RE: **Palen Solar Power Project, Docket No. 09-AFC-7**
Responses to January 14, 2010 CEC Workshop Queries
Technical Areas:
Soil & Water Resources (supplemental data for DR-S&W-242)

Palen Solar Power Project

Soil and Water Data Responses to January 14, 2010 CEC Workshop Queries

DR#242 Supplemental---Soil and Water:

30% Conceptual Engineering Plans
NOT FOR CONSTRUCTION
DATED: January 28, 2010

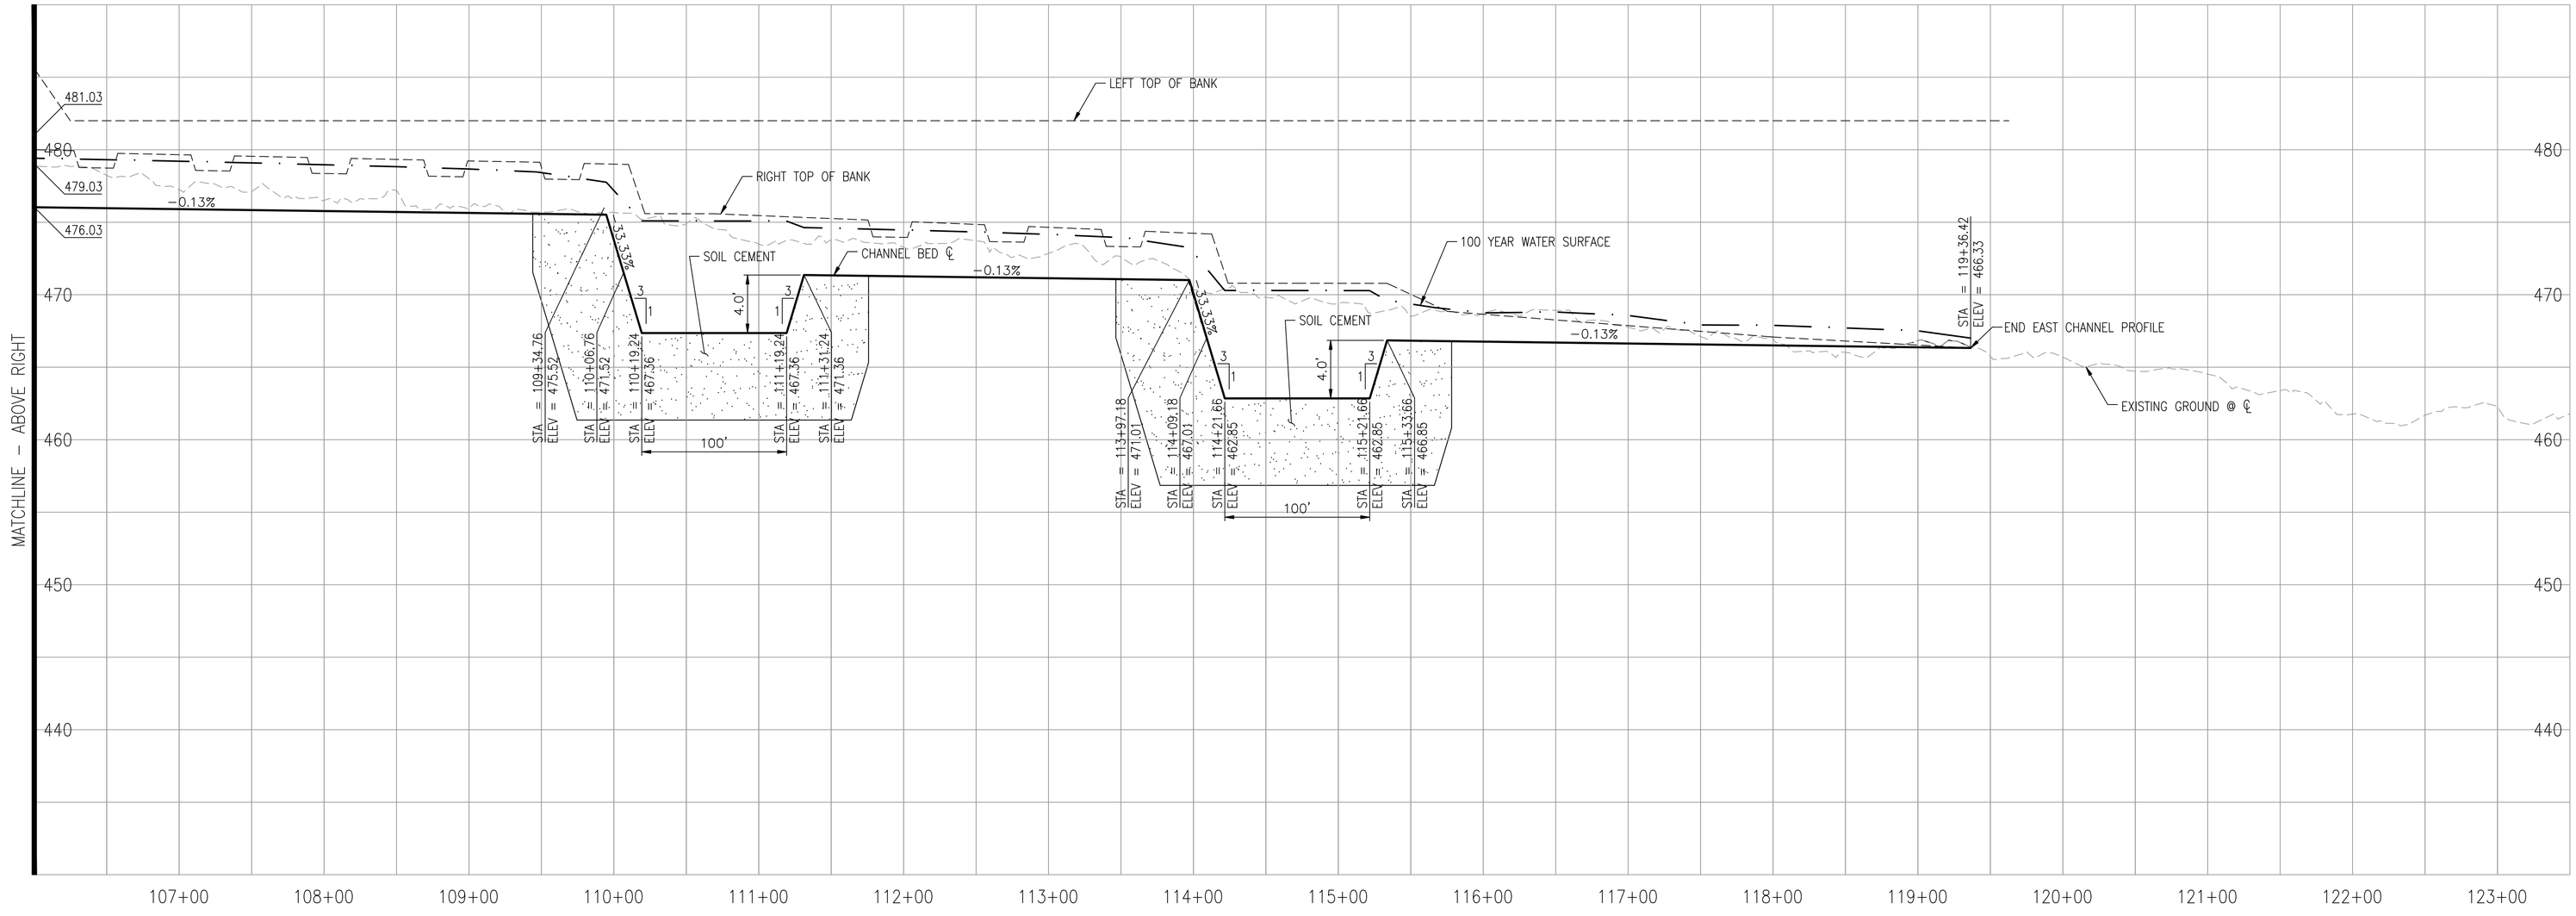
Add 100-yr. water surface elevations on profiles for main channels (both collectors and conveyance).

The 100-year water surface profile has been added to the plans and is provided as part of this response.

INTERCEPTION CHANNELS AT EMBANKMENT

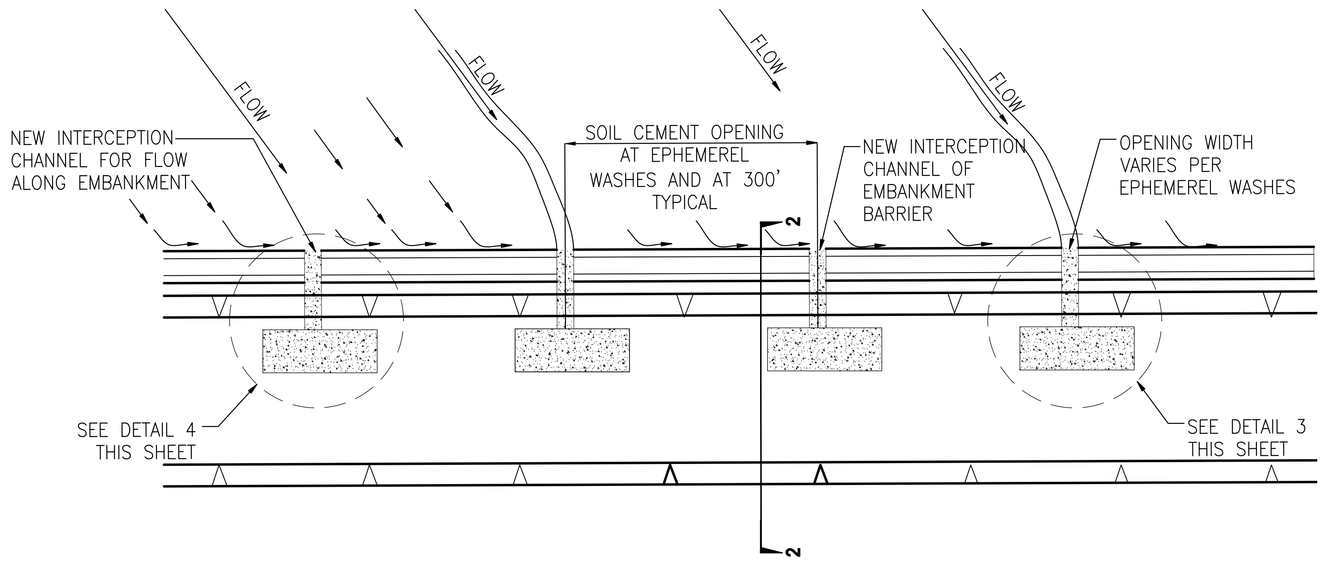
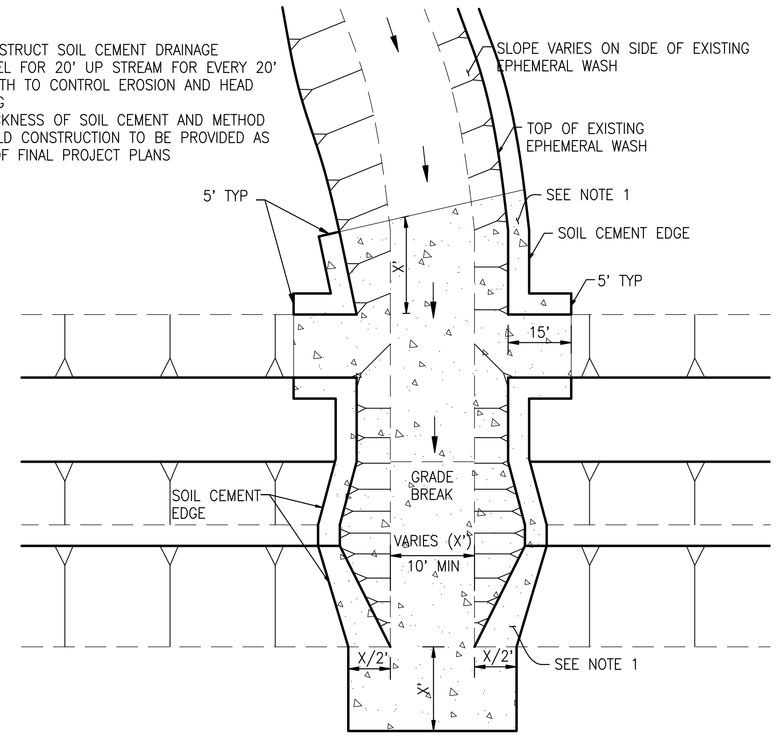
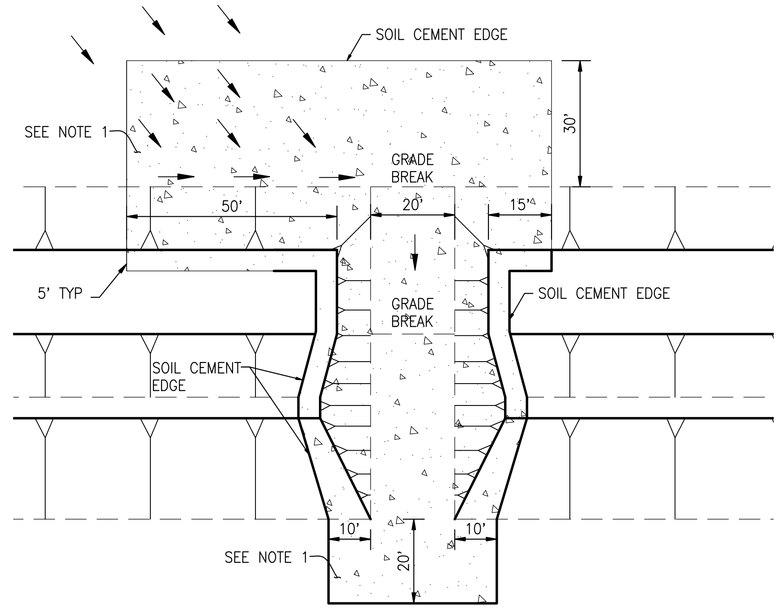
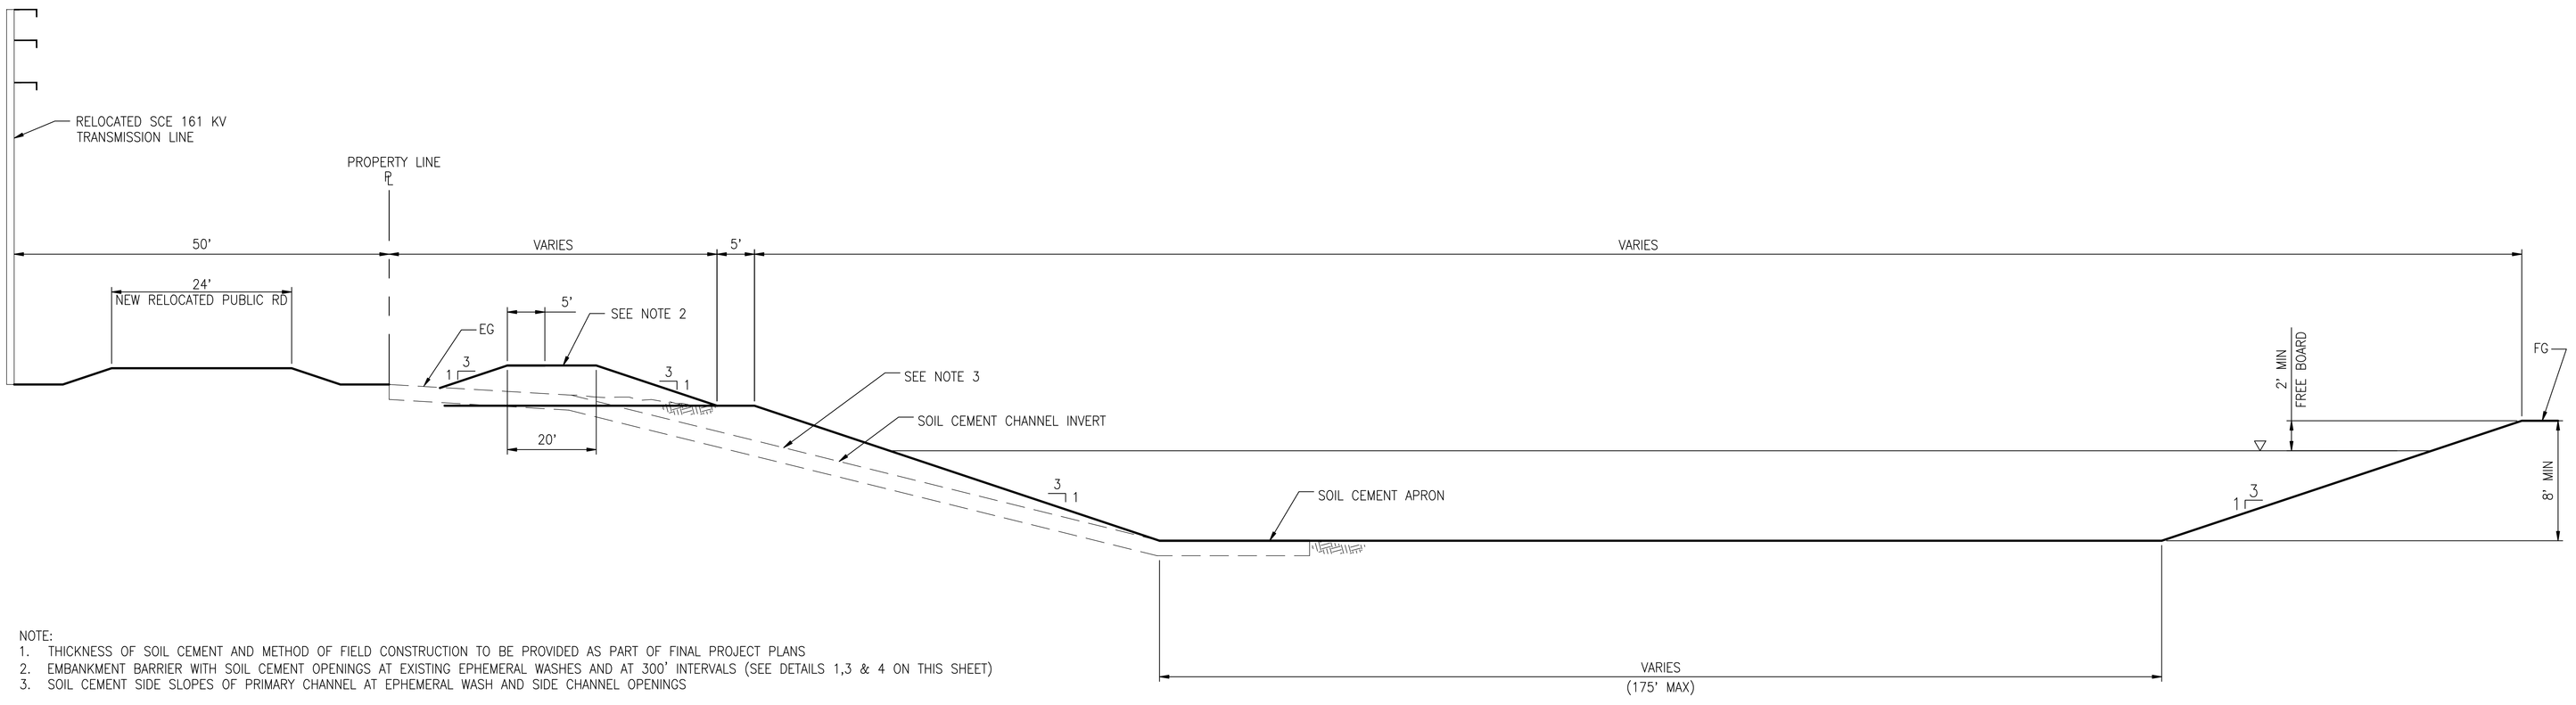
For response to DR-S&W-242, provide fuller explanation of relationship of cut slopes to berms and how water will be managed to avoid headcutting. Provide more detail needed on how water from the west enters the main channel at Palen. For the west channel at Palen, provide greater level of detail on drawings to indicate relationship of cut slopes to berms, channel, and relocated public roadway. Provide section drawings that show gaps in berms to allow water passage from upslope areas.

The issue of headcutting of channels upstream of the site will be precluded primarily by use of soil cement where existing and proposed channels enter into the primary offsite channels and by use of small (20 foot wide and 2.5 feet high) embankments placed upstream of the primary channel to direct existing drainage flows as well as future flows that may migrate into specific localized drainage inlets to the primary off-site drainage channels.

In essence, the small embankment is placed immediately upstream (5 feet away) from the upstream face of all perimeter channels that receive off site flows. This embankment runs the entire length of the perimeter channel. This embankment is then opened up at all locations where it is intercepted by off site ephemeral channels. The opening is constructed at the same current width as the existing ephemeral channel. The drainage path is then carried over the face and down the slope of the primary drainage in a defined “side slope” down-drain. Soil cement is placed within the ephemeral channel upstream of the embankment, through the opening in the embankment, along the full extent of the “side slope” down-drain, and out into the channel with an apron structure. Soil cement is also placed along the faces of the embankment on the upstream and downstream edges to preclude erosion and loss of embankment slope.

Additional details have been provided as part of this response that show this embankment barrier and the interception channels; how they operate, and how they are protected with soil cement, which in turn precludes head-cutting. This detail is shown on Sheet 32 of the revised plans.

The flow into the westerly channel, the relationship of cut slopes to berms, the openings in the berms, and the location of the relocated public road are all addressed by the above discussion as well as the additional details that are provided with this response.
